SUBJECT: REVIEW OF MIT DOCTORAL THESIS BY A. R. SICH, "THE CHERNOBYL
ACCIDENT REVISITED: SOURCE TERM ANALYSIS AND RECONSTRUCTION
OF EVENTS DURING THE ACTIVE PHASE"

Review of Sich Thesis
(Preliminary)

Figure 4.1 Chronology of the accident at the Chernobyl Nuclear Power Station (not to scale)

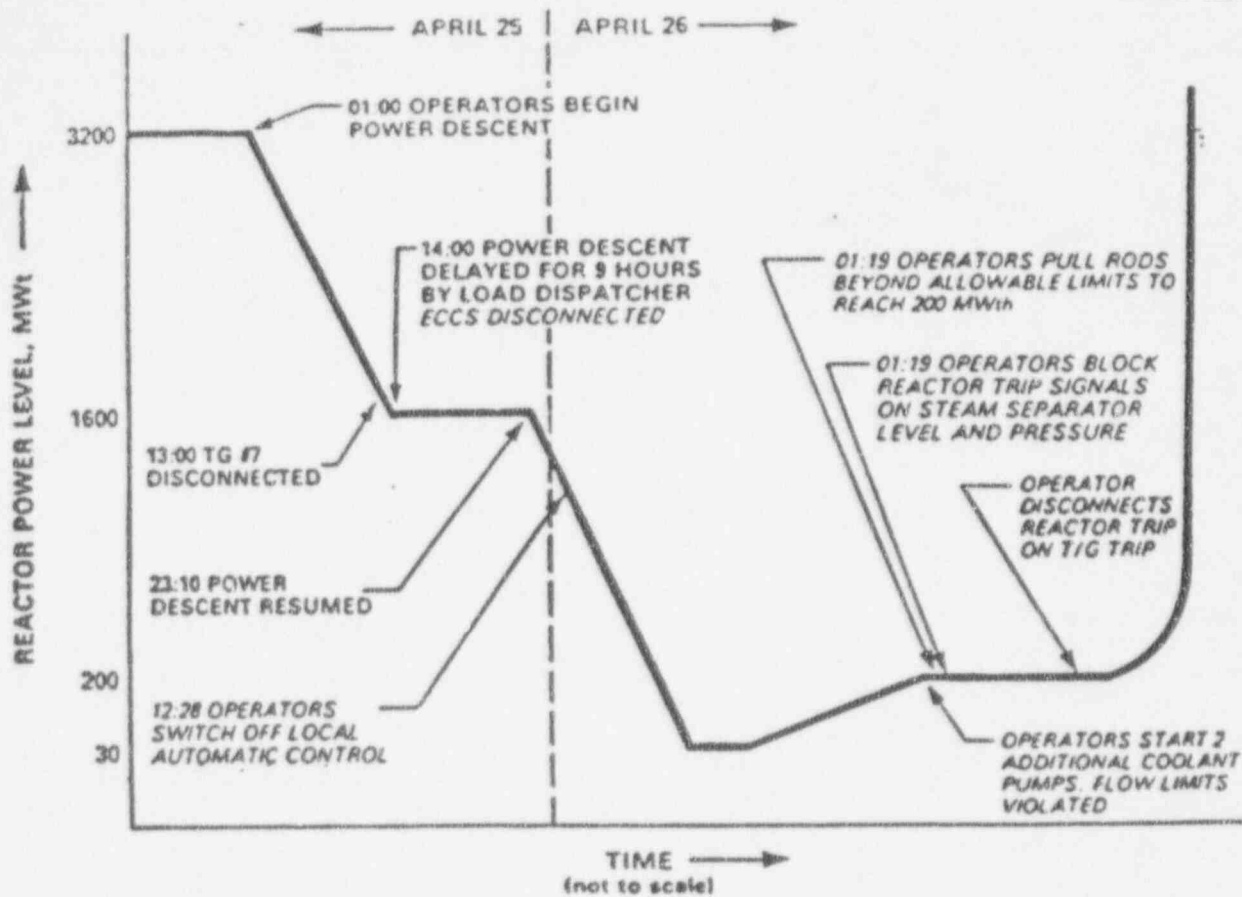
2. The release of I-133 has also been overestimated for two reasons:
 - a) The initial core inventory of I-133 has been overestimated by about 20 percent. This is because the power level of Chernobyl was significantly lower than the value of 3200 Mwt for about a day prior to the accident (Enclosure 2). This does not significantly affect I-131, but has a noticeable effect on I-133. Because of the reduced power level just before the accident, the initial core inventory for I-133 was about 140 Mci, rather than the value of 181 Mci listed by Sich.
